### **I-405, SR520 to SR522 Stage 1 (Kirkland Stage 1)**

**Table of Contents**  
**I-405, SR520 to SR522 Stage 1**  
**Design Deviation Papers**

### Design Deviation #1

NB I-405 Superelevation Transition Location

Arterial Vertical Stopping Sight  
Distance Design Deviation  
Exhibit 1  
Proposed Design

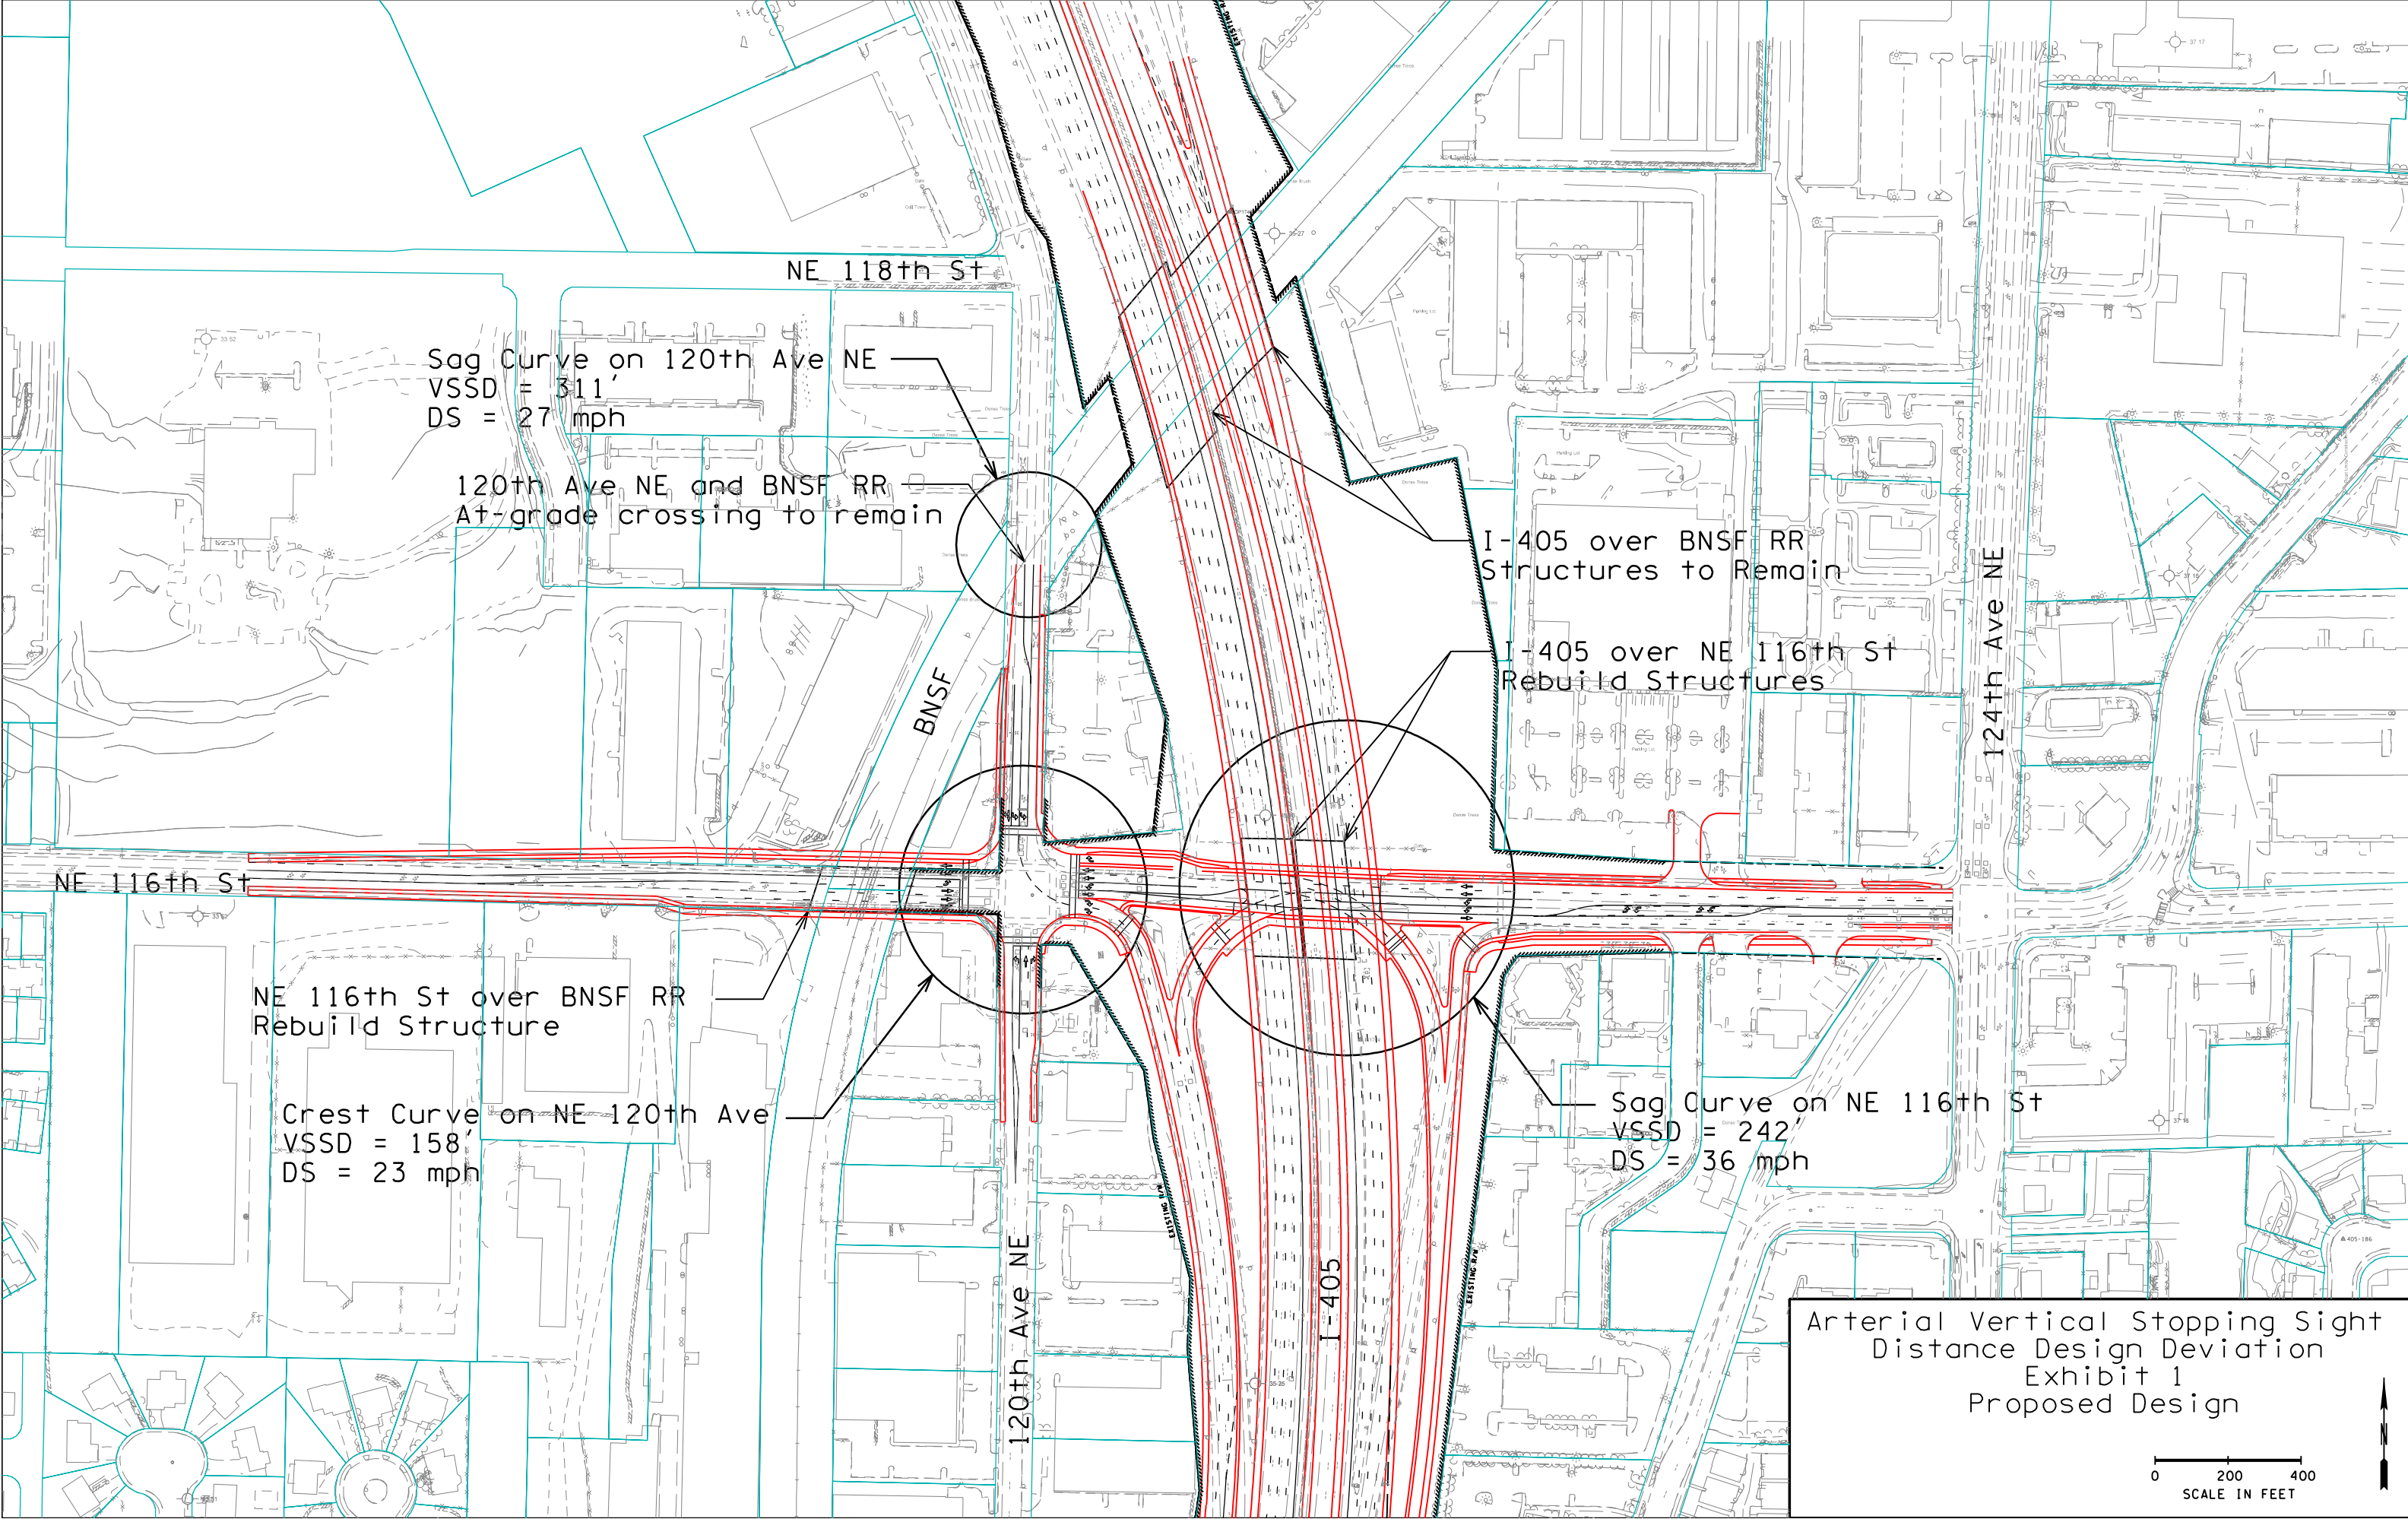
The sag vertical curve on NE 116<sup>th</sup> St under I-405 has an existing stopping sight distance of 242 feet, which corresponds to a design speed of 36 mph. The crest vertical curve over the BNSF has an existing stopping sight distance of 411 feet, which corresponds to a design speed of 52 mph. The posted speed limit is 35 mph and the proposed design speed is 45 mph.

The sag curve on 120<sup>th</sup> Ave NE at the BNSF crossing has a stopping sight distance of 311 feet, which corresponds to a design speed of 27 mph. The crest curve at the intersection with NE 116<sup>th</sup> St has a stopping sight distance of 158 feet, which corresponds to a design speed of 23 mph. The posted speed limit along 120<sup>th</sup> Ave NE is 25 mph south of NE 116<sup>th</sup> St and 30 mph to the north. The design speed for 120<sup>th</sup> Ave NE is 30 mph for the entire project limits.

*Build to Full Standard* – Raise the profile of both I-405 and NE 116<sup>th</sup> St in order to flatten the vertical sag curve and grade separate the 120<sup>th</sup> Ave NE and BNSF crossing. Achieving a 45 mph design speed for the sag curve on NE 116<sup>th</sup> St necessitates flattening the grade of one of the approaches. Lowering the grade on the west approach is more feasible, because of the planned improvements to NE 116<sup>th</sup> St and 120<sup>th</sup> Ave NE. Overall, the profile would be raised approximately 6 feet under I-405 and as much as 3 feet at the intersection with 120<sup>th</sup> Ave NE. The NE 116<sup>th</sup> St over BNSF structure needs to be rebuilt with a deeper structure depth due to the widened bridge width, which would require raising the profile of NE 116<sup>th</sup> St approximately 1 foot to maintain 23.5 feet of vertical clearance over the railroad. All of these factors on NE 116<sup>th</sup> St will require raising I-405 approximately 10 feet to ensure standard clearances and an efficient bridge depth. Raising the I-405 mainline this much will necessitate rebuilding the I-405 overcrossing structures at BNSF.

*Proposed Design* – Raise the profile of I-405 to provide adequate clearance over NE 116<sup>th</sup> St without rebuilding the I-405 overcrossing of BNSF and the vertical curves along NE 116<sup>th</sup> St and 120<sup>th</sup> Ave NE (see Exhibit 1). I-405 would be raised approximately 4 feet NB and 6 feet SB to provide adequate vertical stopping sight distance, to allow for standard vertical clearance over NE 116<sup>th</sup> St and to enable a more efficient structure type. Approximately one inch of additional asphalt overlay would be necessary on the SB BNSF overcrossing structure, while the load rating of the NB BNSF overcrossing

- The Full Standard option would require rebuilding in the Nickel Project structures that are planned to be upgraded in the Master Plan. The I-405 overcrossing of the BNSF railroad structures will be replaced when the NE 124<sup>th</sup> St interchange is rebuilt in the Master Plan. The Implementation Plan is to widen the existing SB structure but not affect the NB structure. The new crossing of 120<sup>th</sup> Ave NE over the BNSF is not planned by either WSDOT or the City of Kirkland. Additionally, 120<sup>th</sup> Ave NE at the BNSF crossing is outside the limited access area owned by WSDOT. It would cost approximately \$68 Million to build the "full standard" option.

- The Proposed Design prioritizes fixing non-standard conditions along I-405 and meets standards in all new elements. The existing sight distances along NE 116<sup>th</sup> St meet the posted speed limits, while the distances along 120<sup>th</sup> Ave NE are at or near the posted speed limit. The arterial roads in this area do not have a high volume of accidents per city records. As mitigation to the sag curve on NE 116<sup>th</sup> St, the new bridge will have flood lighting underneath it to enhance nighttime visibility. The sag curve on 120<sup>th</sup> Ave NE will also be mitigated with new lighting to enhance nighttime visibility during Stage 2 construction.

Limited Access Design Deviation  
Exhibit 1  
Existing Operation at 116th

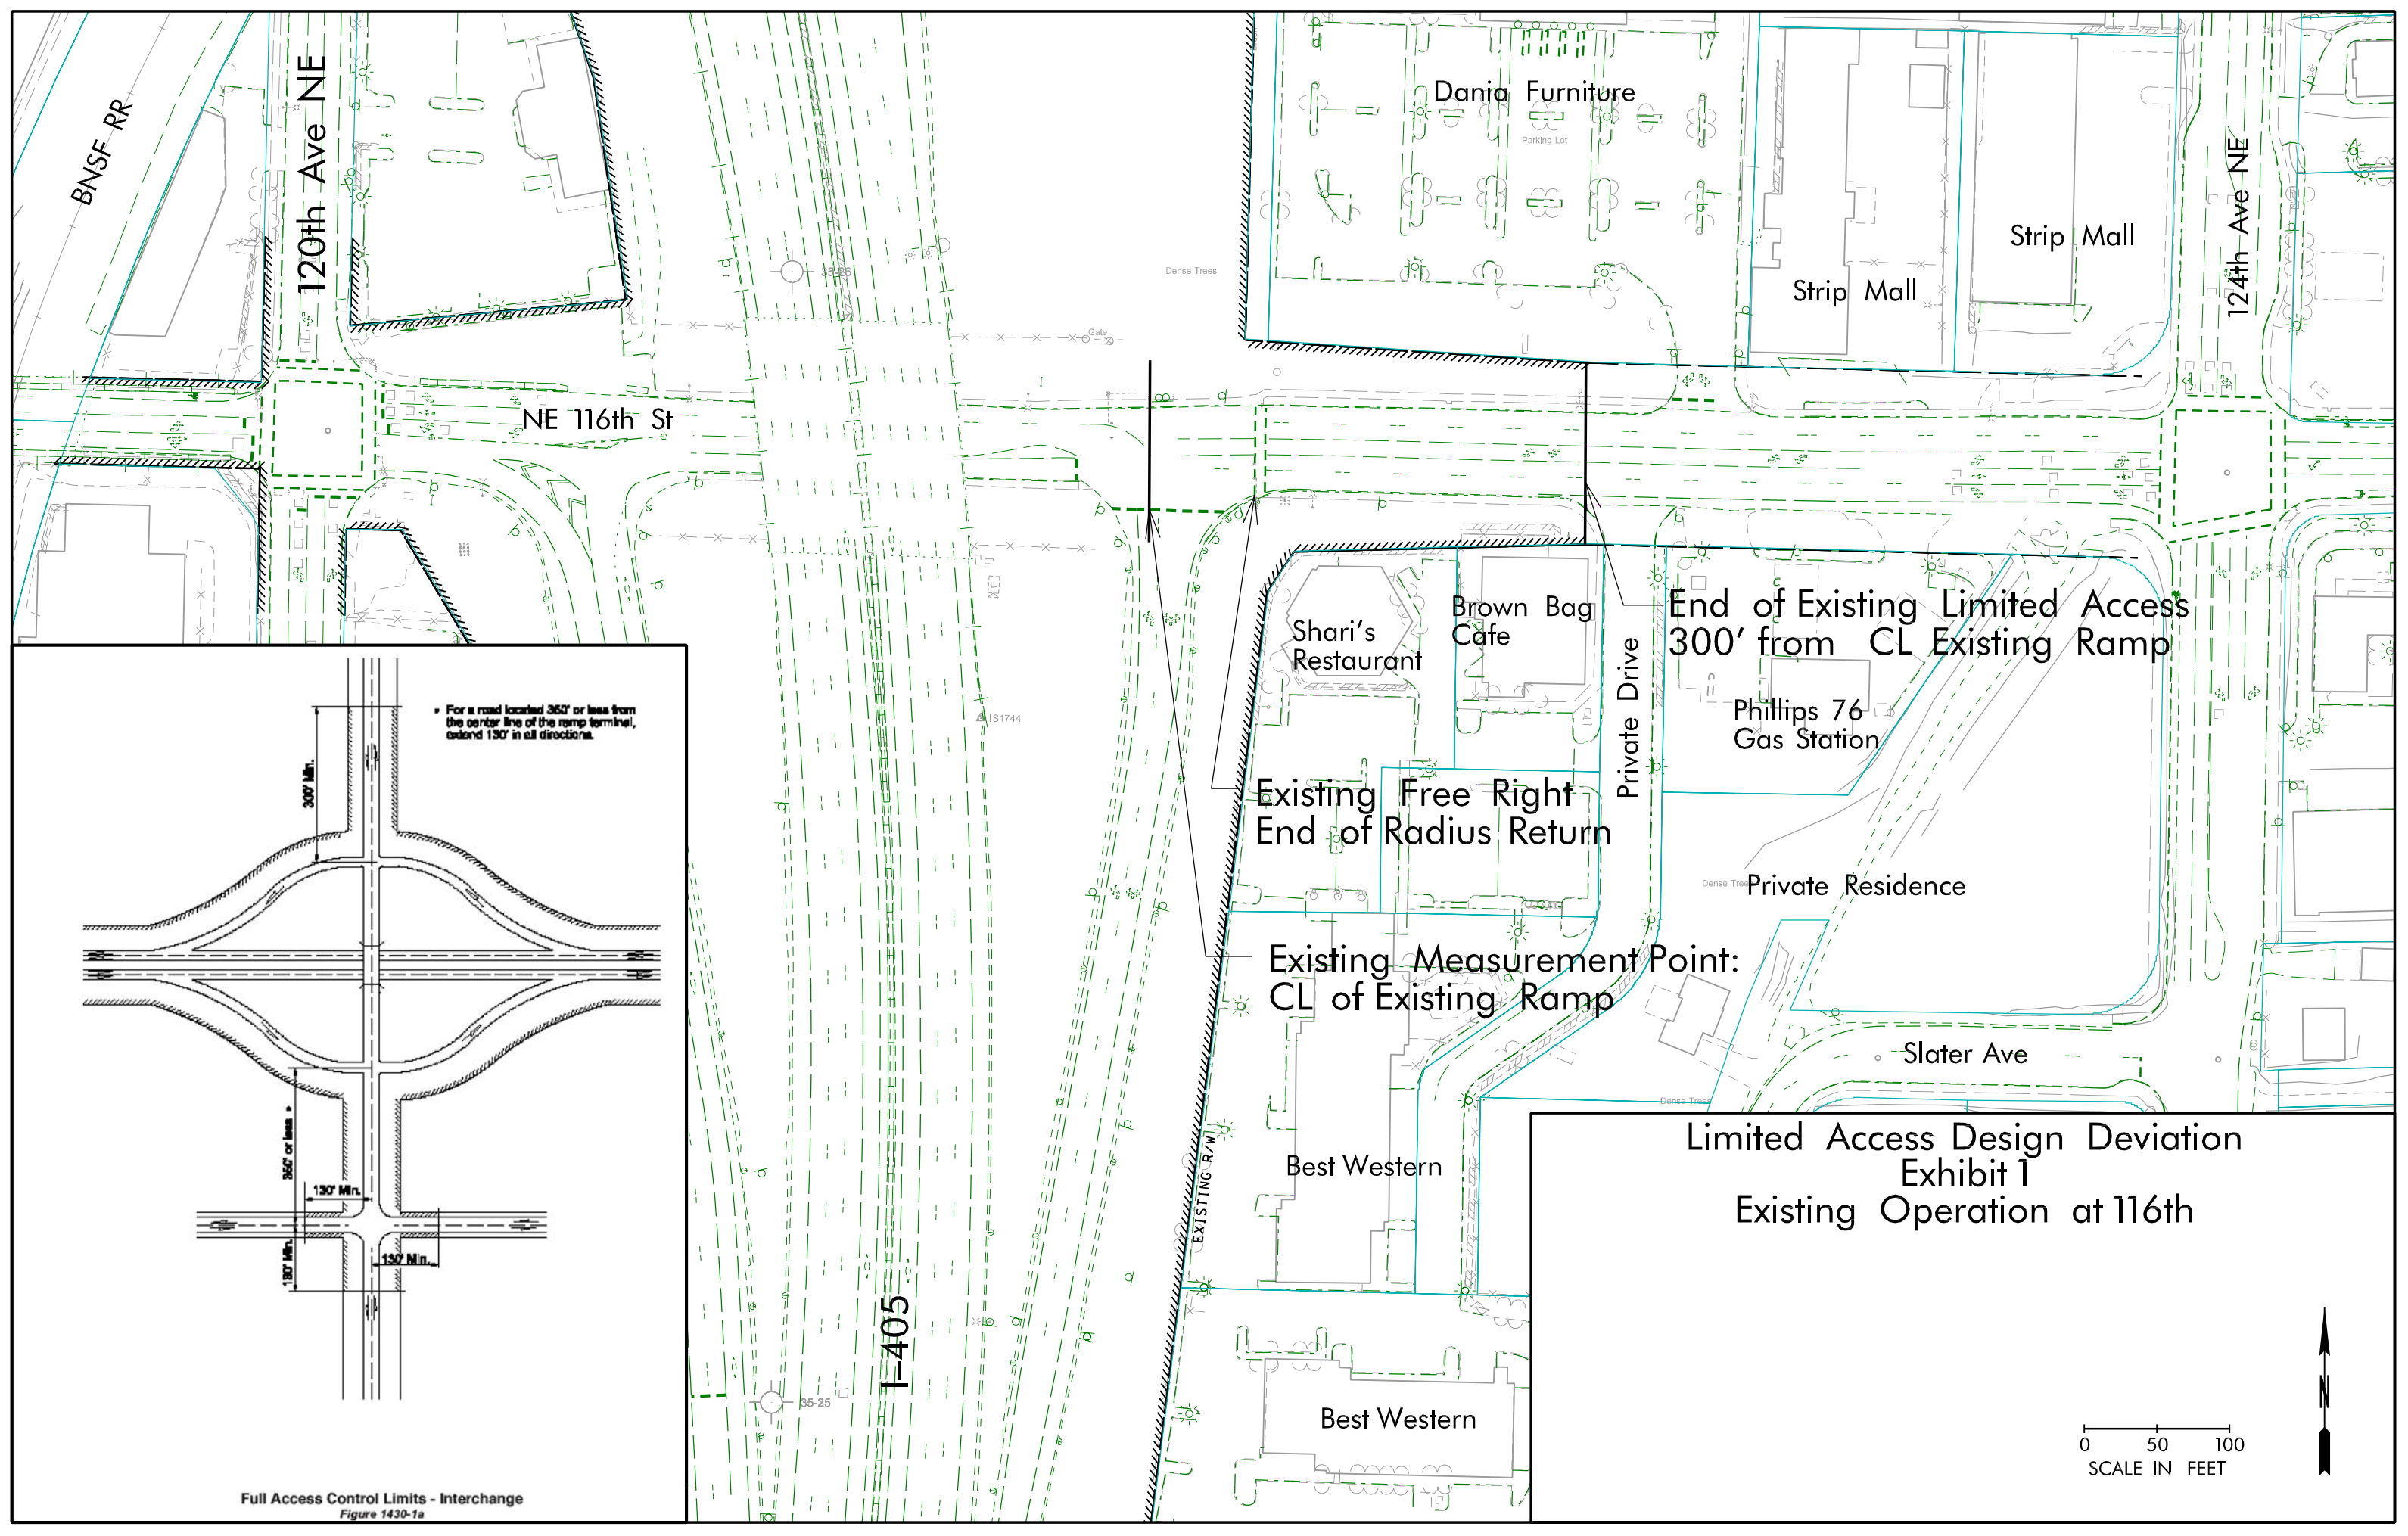
The existing I-405 mainline, NB and SB, is four 12 foot lanes, a varying inside shoulder and a 10 foot outside shoulder. The NE 116<sup>th</sup> St interchange is a half diamond to the south. NE 116<sup>th</sup> St has four lanes under I-405, widens to five lanes east of the interchange and narrows to three lanes across 120<sup>th</sup> Ave NE to the west. (See Exhibit 1)

This deviation proposes maintaining the existing limited access control point on the east side of I-405 along NE 116<sup>th</sup> St. The proposal would result in 235 feet of limited access control as measured from the juncture of the SPUI right turn branch and NE 116<sup>th</sup> St. to the existing limited access control point. See Exhibit 3 for a comparison of existing and proposed limited access control point, standards and measurements.
